# **Hogg's Hollow Storm Water Management and Road Improvement Study**

**Public Consultation Report  
November 9, 2004**

## Public Consultation Report

##### *Design details*

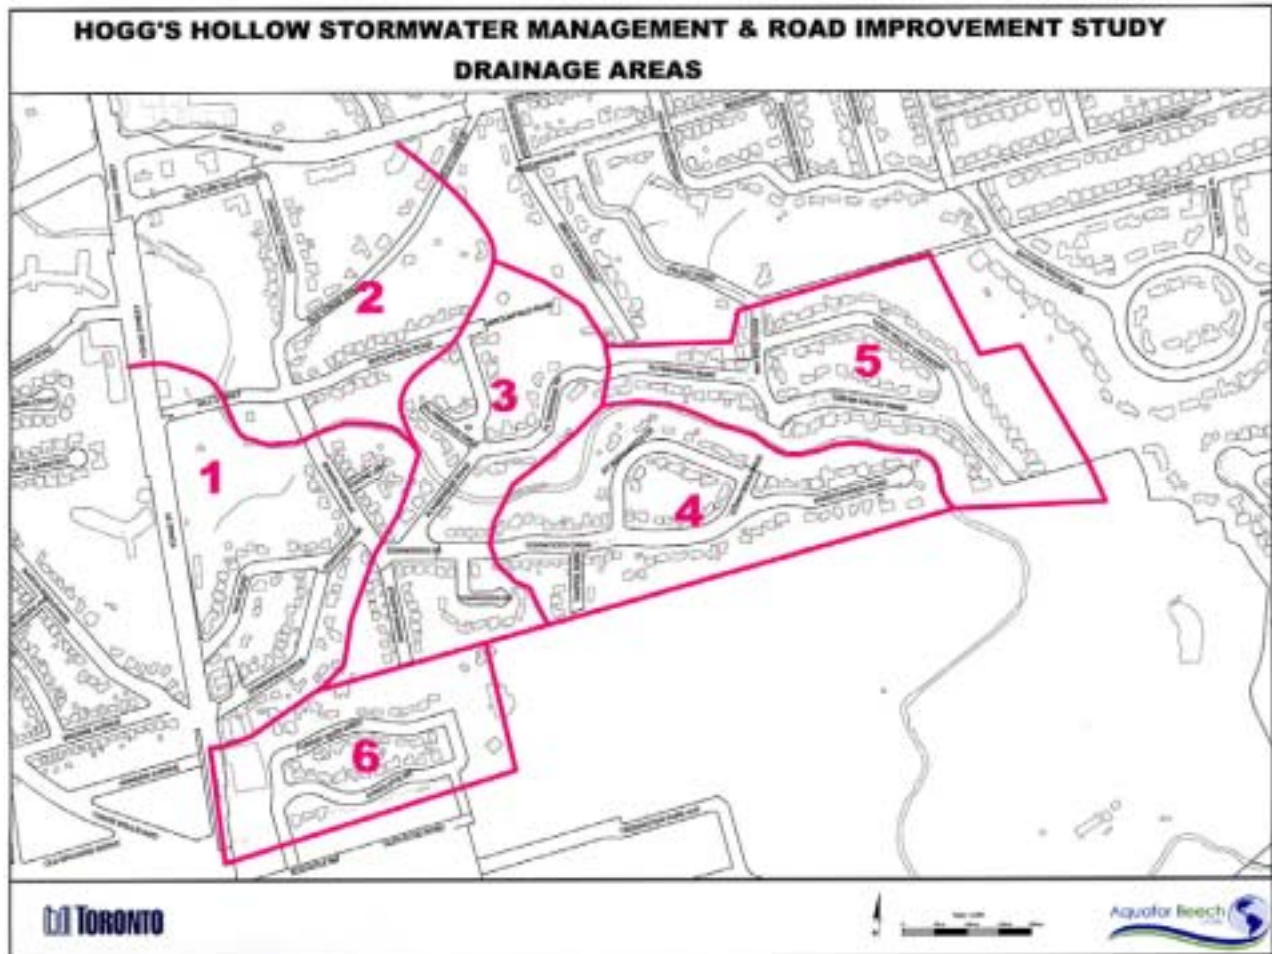
- 📍 As a design detail, can alternate curb colouring be considered?
- 📍 The residents requested that, as part of the construction, a centre island on their street be curbed, resulting in better demarcation.
